TO: Service Locations

FROM: Service Systems Development

SUBJECT: **GHG14 DD13™ Turbocharger Wastegate Service Kit**

Figure 1 – Seized Wastegate Mechanism

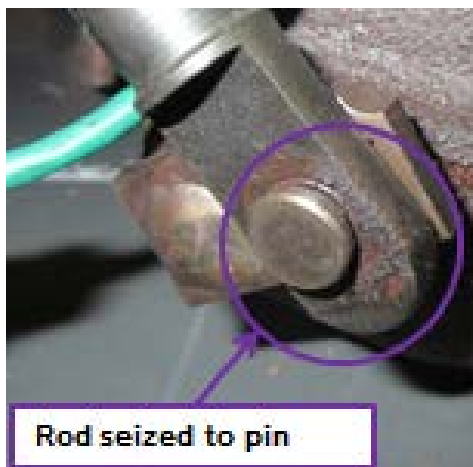
The cause of the code may be a stuck turbocharger wastegate mechanism due to several reasons, such as corrosion or a faulty wastegate diaphragm. See Figure 1.

If the troubleshooting finds the turbocharger wastegate mechanism faulty, replace the mechanism with wastegate service kit P/N: A4710961769. This new serviceable wastegate has improved corrosion resistance.
